Planning and Zoning Board Agenda August 14, 2018

- C. Site Plan - Ellianos Coffee Co.: A request by Christopher Gmuer, P.E., of Gmuer Engineering, Inc., applicant and agent for Circle K Stores, Inc., property owner, for consideration of a Site Plan to construct a ±681 square foot drive through restaurant, with associated paving, grading, drainage, landscaping and infrastructure improvements, on a ±1.03 acre subject property, located at the southeast corner of the intersection of NW US Highway 441 and County Road 235A; Tax Parcel Number 03051-004-000 (Quasi-Judicial Hearing).

- D. Site Plan - Legacy Park Phase 2A: A request by Travis Hastay, P.E., of Causseaux, Hewett, & Walpole, Inc., applicant and agent for the City of Alachua, property owner, for consideration of a Site Plan for the construction of an amphitheater with stage and canopy structure, two (2) multipurpose fields, concessions / restroom building, and associated parking, drainage, paving, grading, and infrastructure improvements on a ±105.68 acre subject property, consisting of a ±17.83 acre project area, located at 15400 Peggy Road; Tax Parcel Number 03870-000-000 (Quasi-Judicial Hearing).

FL PE No. 84295
SHEET NO.:
C1.10

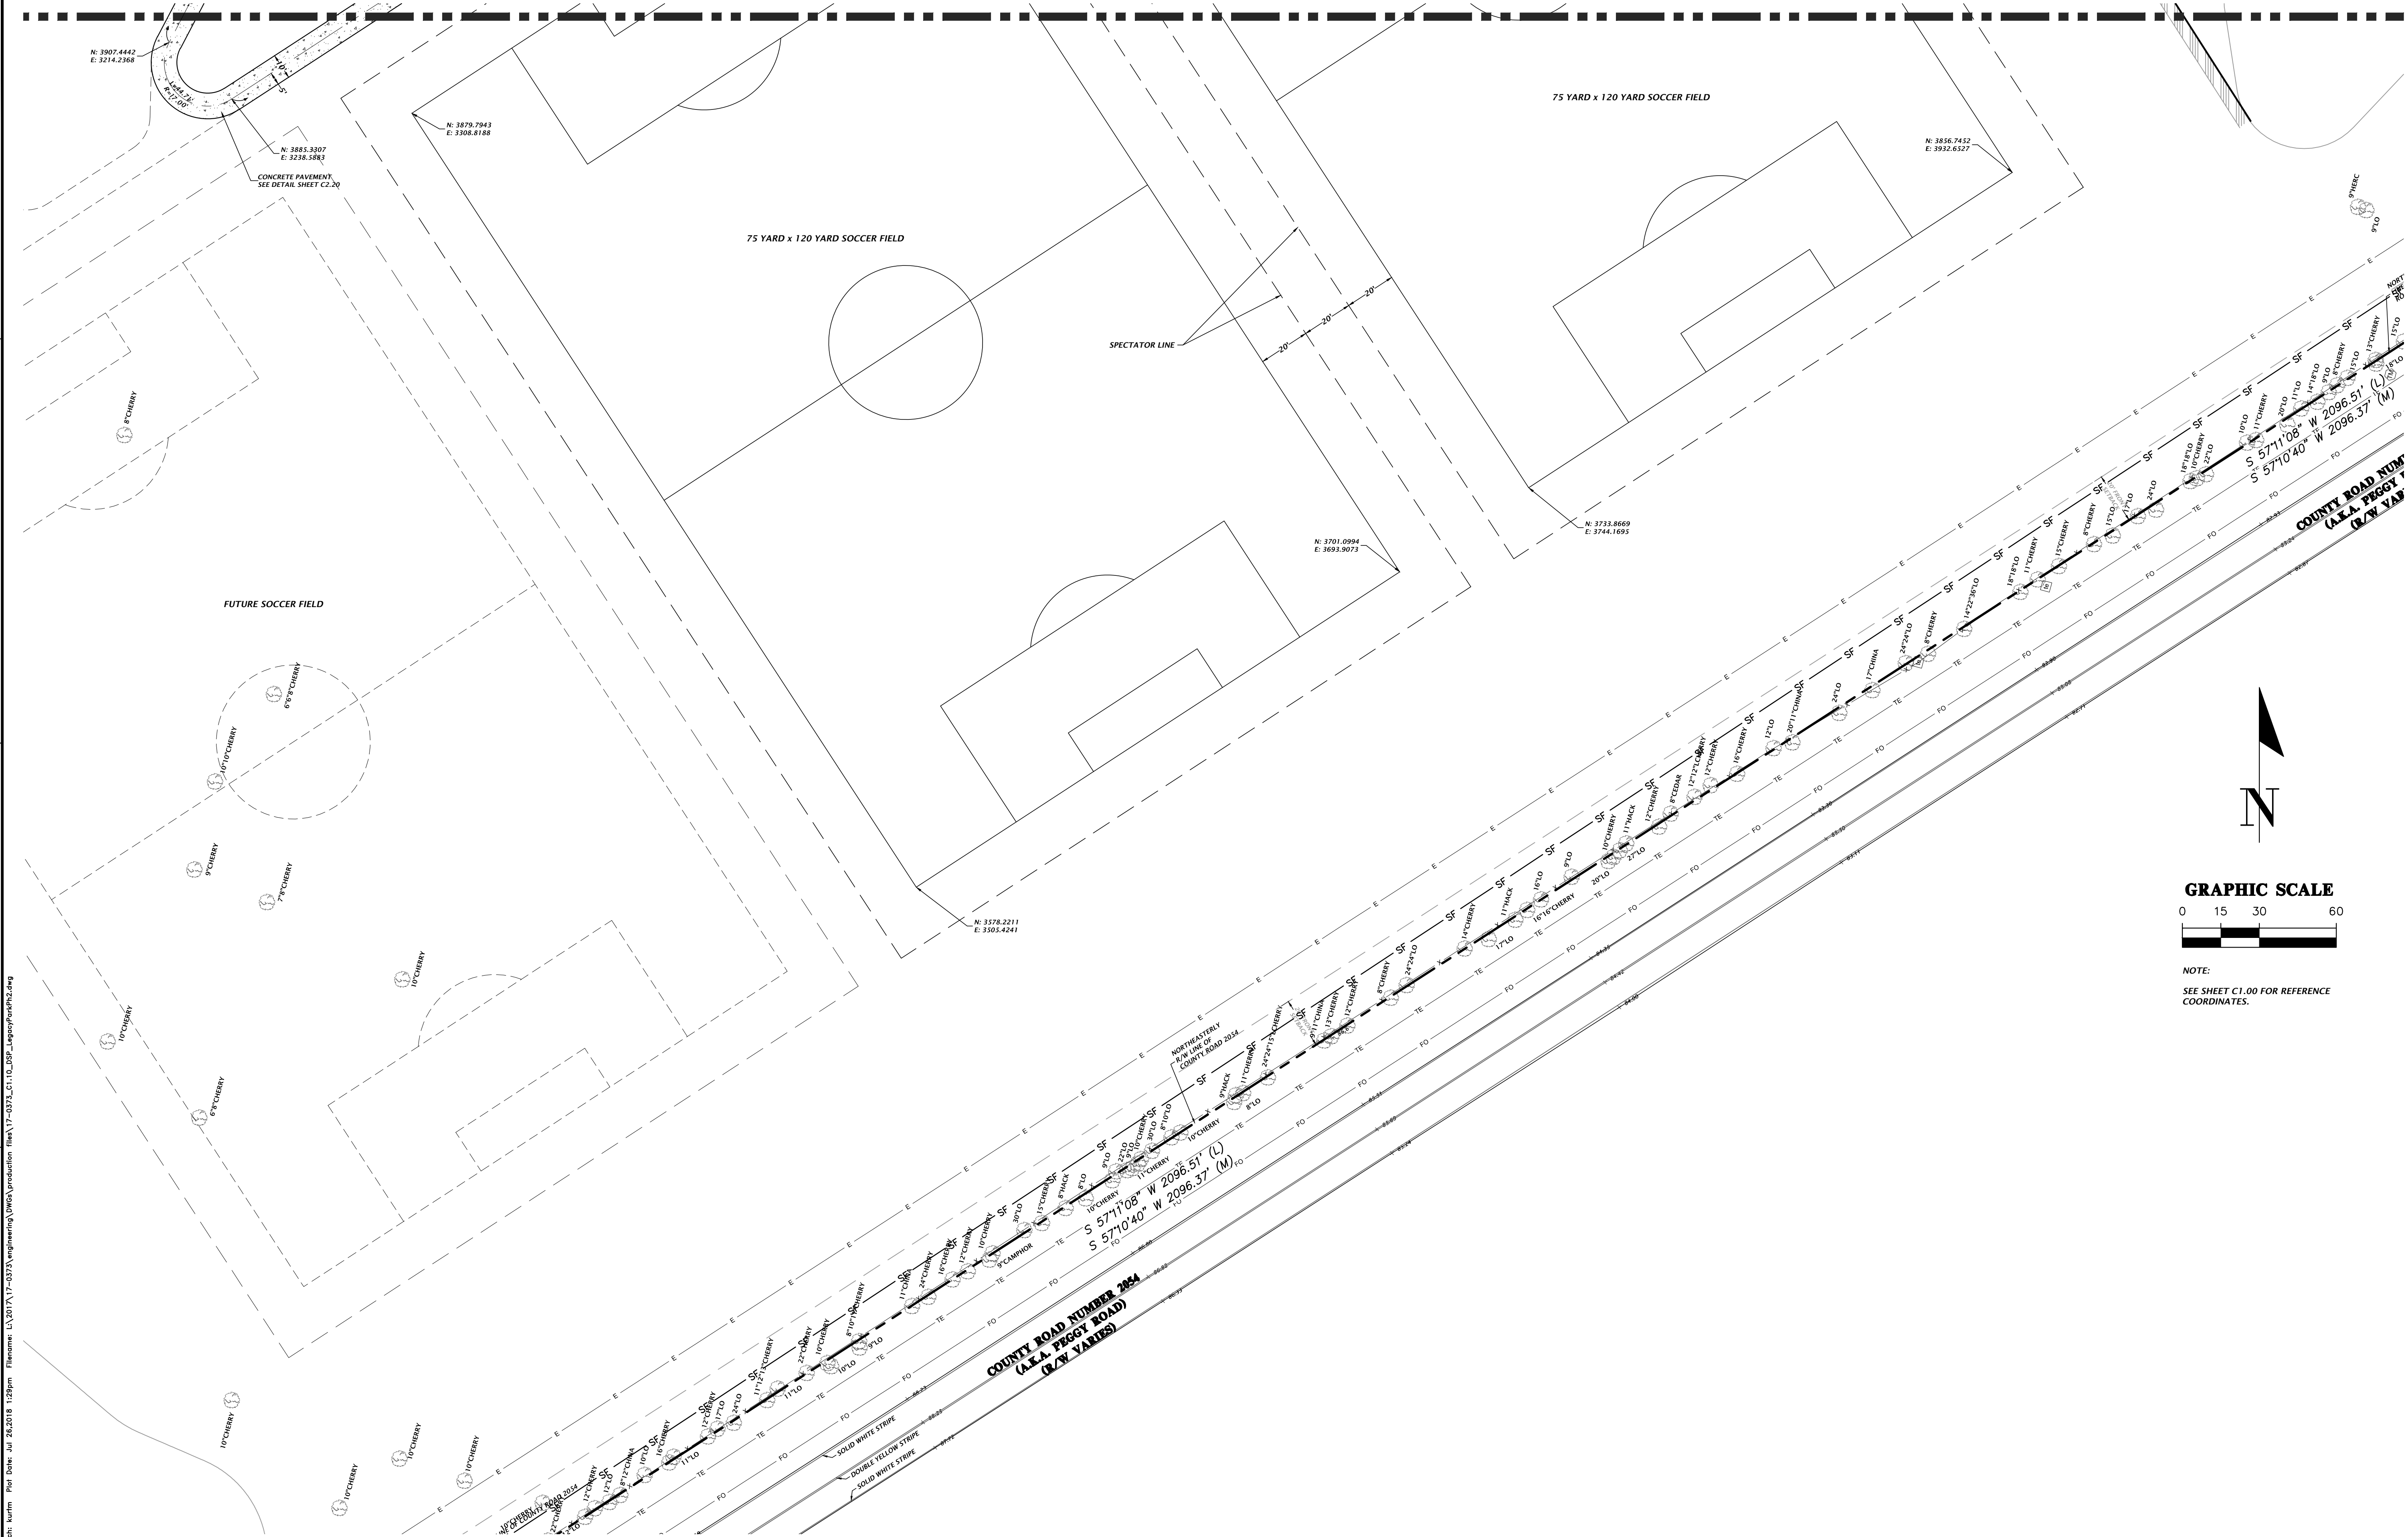
- b. Sheet C1.10: Riprap shown SE of bathroom/concessions building but no other stormwater detail shown on this sheet.
 - c. Sheet C1.10: Please address how the sidewalk along the north side of the access drive into the site (south of the existing paved parking lot) will connect to this phase and to future phases.

SHEET NO.:
LS-2

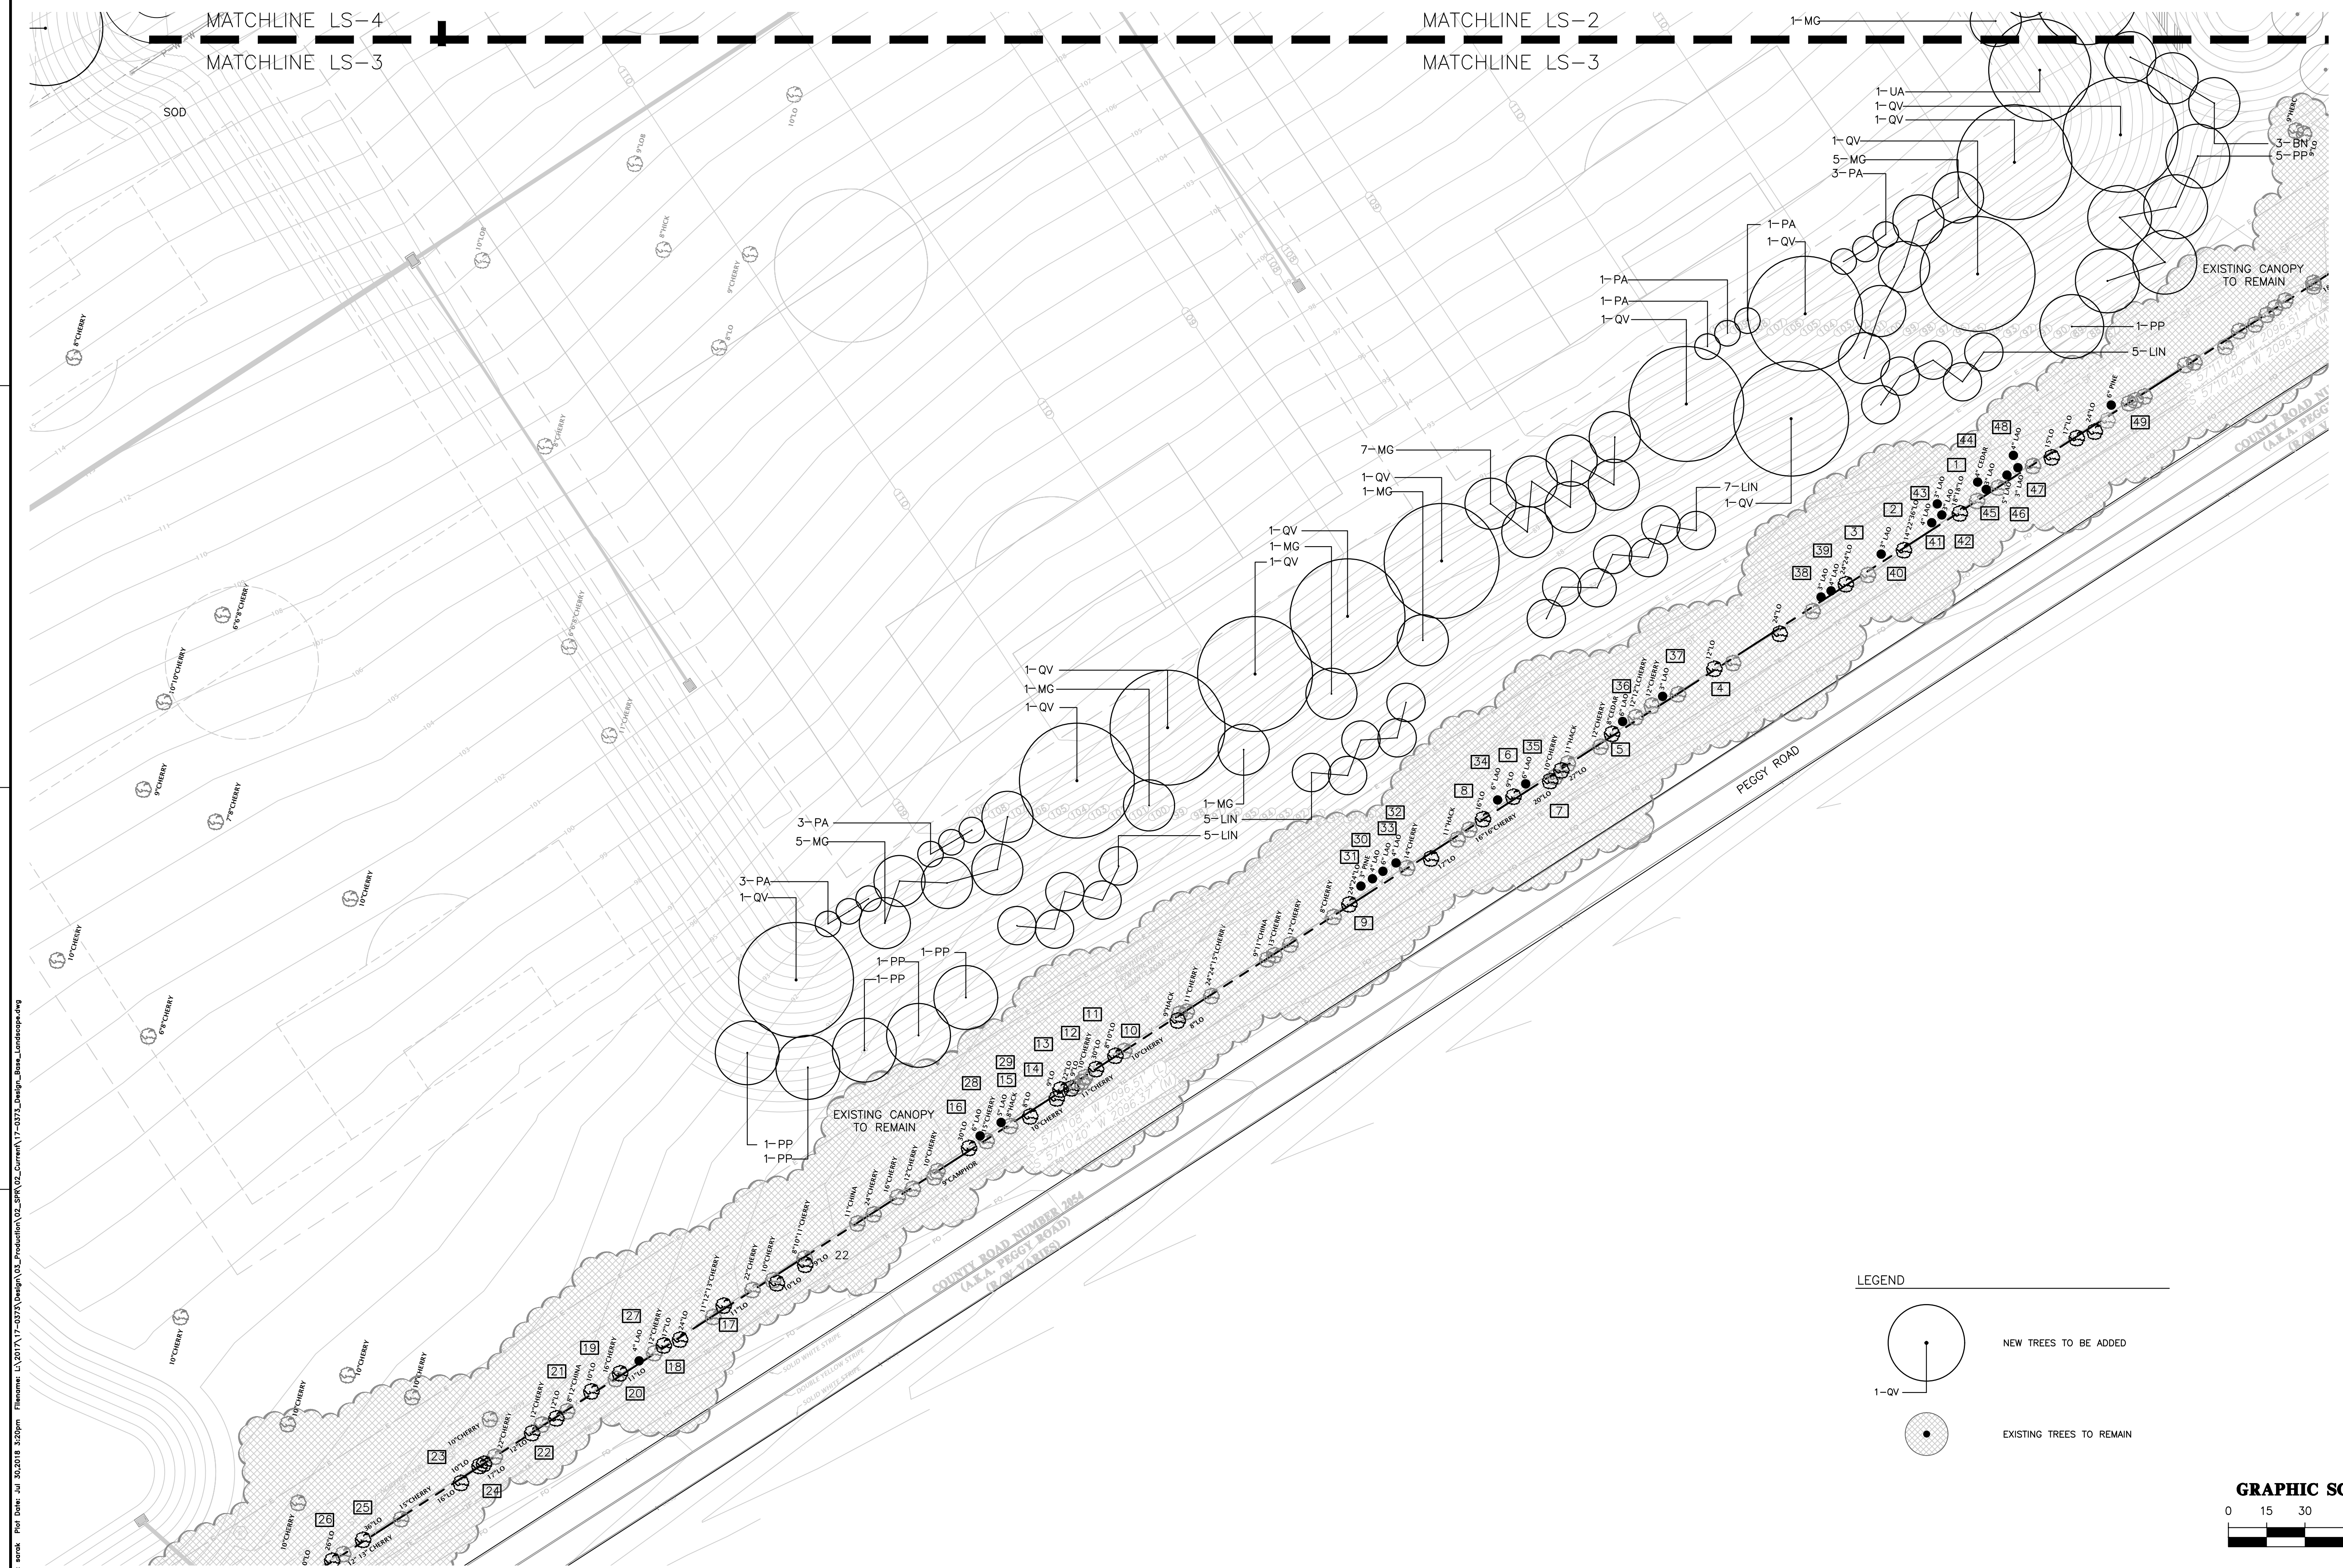
- c. Grading, Drainage and Utility Plan sheets (C2.00 – C2.16) do not show all existing trees (for example, there are existing trees in the northern area of east field, as shown on Sheet LS-2). Please ensure plan sheets show all existing trees, including those to be removed and those to be preserved.
